HORSHAM DISTRICT COUNCIL CONSULTATION

TO:	Horsham District Council – Planning Dept
LOCATION:	Berkeley Homes Development Site Worthing Road Southwater RH13 9BT
DESCRIPTION:	Erection of 94 dwellings with associated access, parking and landscaping at Land West of Worthing Road (Phase 5), Southwater
REFERENCE:	DC/19/2464
RE-CONSULT:	1 st set of comments in black 2 nd set of comments in blue 3 rd set of comments in green 4 th set of comments in purple
RECOMMENDATION:	Advice
SUMMARY OF COMMENTS & RECOMMENDATION: 5th set of comments in orange The changes to address some of our concerns are noted and welcomed. Detail conditions are recommended below in order to secure those details that haven't been addressed at this stage. 4th set of comments The majority of recommendations below could be secured through condition, however minor modification is requested in regard to layout and securing landscape strategy. We highlight in particular, points 5, 6, 9, 12, 13 and 14. 3rd set of comments See below 2nd set of comments See below 1st set of comments As discussed please see below a few bullet points on the main issues with the current layout for discussion. Please note I don't provide comments o

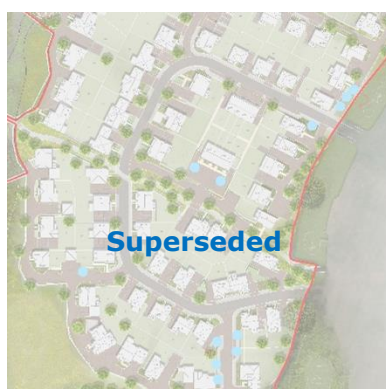
9. On our most recent site visit, although it was a foggy day, we noticed that there are views from the public footpath 1654 towards Chanctonbury Ring on the SDNP and also potentially views within the site. This view towards a notable landmark should be maintained if possible and a study carried out to see if the site layout can be adjusted and/or building heights restricted to allow for a corridor view. If the view corridor can be accommodated, the applicant should consider the inclusion of a interpretation board pointing out the view as I would imagine this pubic footpath will become very well used

I believe, the proposed trees in the north west corner will block the Chanctonbury Ring view that we are trying to retain. Now that site visits can go ahead, I think this should be demonstrated with a verified view and a viewing corridor marked within the plan to inform positioning not only of building but also any proposed trees.

Ongoing. We note the positioning of a 2m bund in this location raising concerns that the views towards the SDNP can still be retained as requested. We emphasize that demonstrating the retention of this viewing corridor at this stage is strongly recommended. **Not addressed**

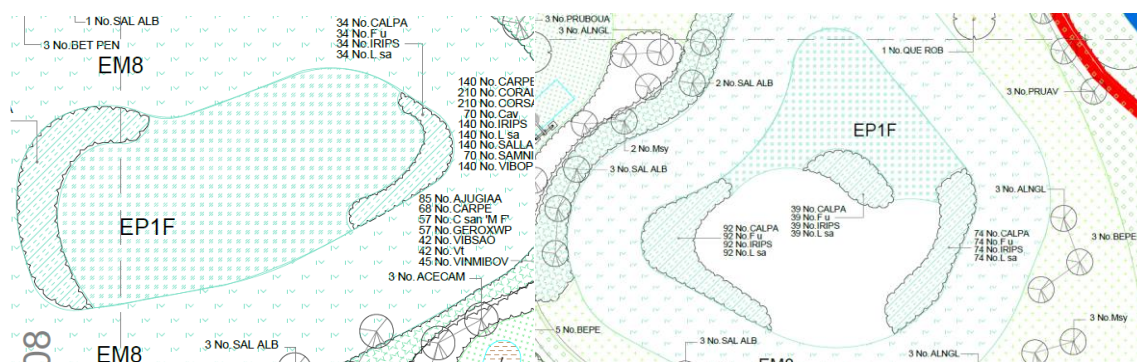
12. Additional mark-up trees suggested shown on the attached plan

Addressed in part, however the scheme has since been updated and trees relocated. Please see below [indicated in blue] a few more areas where we think tree planting could be accommodated. **Closed, thank you**

Service runs and utilities must be considered and coordinated with tree planting so that they are not lost later on in the process.
